RO INSPECTION REPORT NO. 50-219/73-15
JERSEY CENTRAL POWER AND LIGHT COMPANY

OYSTER CREEK DIESEL GENERATOR RESTART PROBLEMS - DOCKET NO. 50-219

Section II - Diesel Generator Circuit Modifications (V. Thomas)

TYPICAL
 DIESEL GENERATOR CIRCUIT (PARTIAL)
 MODIFICATION

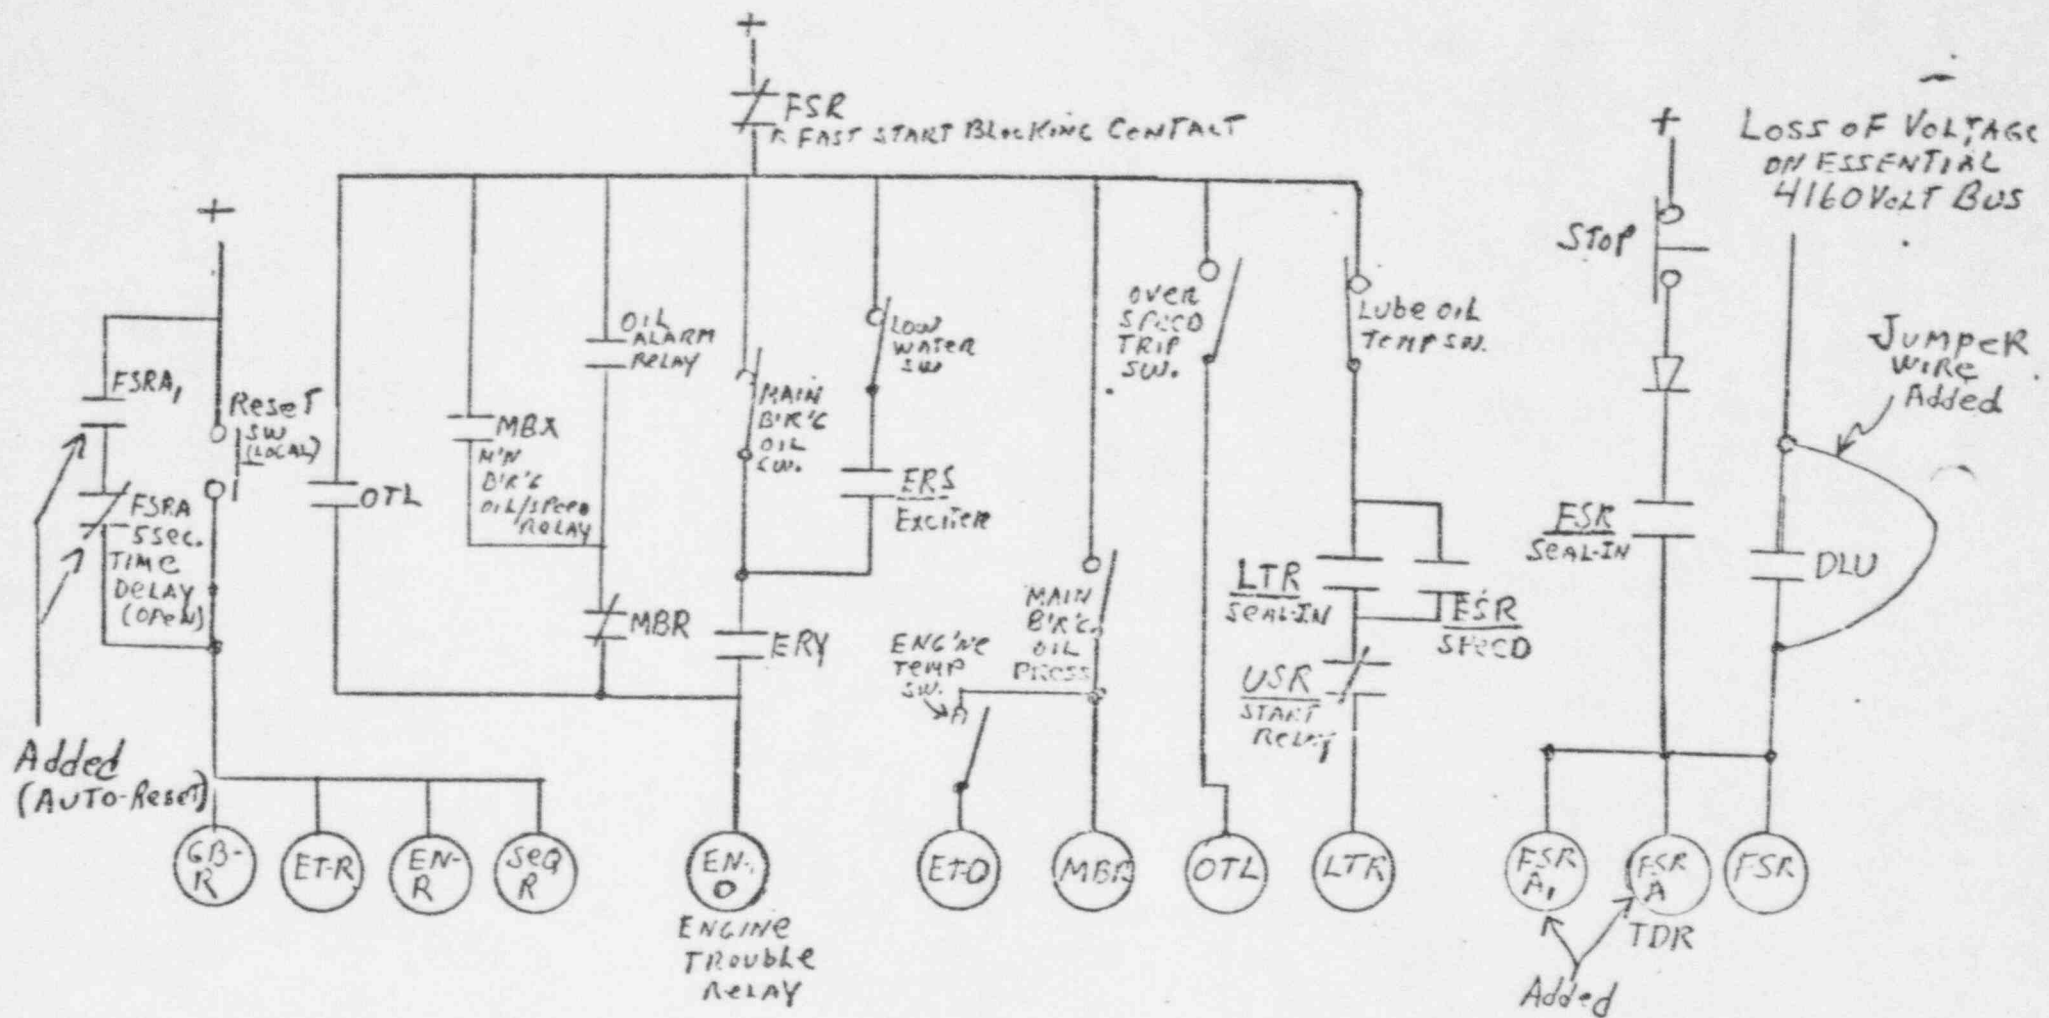
The licensee stated that subsequent to the problem experienced with the diesel generators during the recent loss of power event, investigation into the matter resulted in modifications of the diesel unit's fast-start, and restart circuitry. These corrective measures are discussed below and are also shown on Figure 1, a simplified schematic of the diesel generator's starting circuitry.

The corrective measures taken by the licensee involved the installation of two relays and a jumper wire. The two "fast-start" auxiliary relays identified as FSRA (time delay) and FSRA₁ (instantaneous), are installed parallel to the existing "fast-start" relay (FSR). The jumper wire is installed around the set of contacts of the "dead-line" (DLU) relay. In effect, these modifications now permit the FSR, FSRA, and FSRA₁ relays to be energized simultaneously upon loss of power to any essential 4160 volt bus even though an engine-fault is present. This automatic reset feature is made possible because of the following additional circuit changes:

1. A set of contacts from each new relay, FSRA and FSRA₁, is now installed in a series parallel circuit arrangement (see Figure 1) around the existing local reset button that is wired in the diesel generator's engine-fault reset circuitry.

2. The set of contacts from the FSRA relay has a five second time delay "to open" feature while the other set of contacts from the FSAR₁ relay has an instantaneous "to close" feature. This mode of contact operation occurs only when FSRA and FSRA₁ relays are energized.

In summary, the contact operation combined with the circuit arrangement as discussed now provided the licensee with a "built-in" automatic five second reset feature to clear any engine-fault during a diesel generator fast-start situation. There is no longer a need to manually reset the machine to obtain a "fast-start" following a manual shutdown of the unit. It is well to note, however, that the auto-reset feature has no effect during manual operation of the diesel generator. In manual operation, local reset action following unit shutdown is still required.

Our review of the above circuit modifications revealed that these corrective actions have been completed. We also reviewed the licensee's abnormal occurrence report, and his test procedures of the diesel unit following the above modifications, and no items of discrepancy were noted.
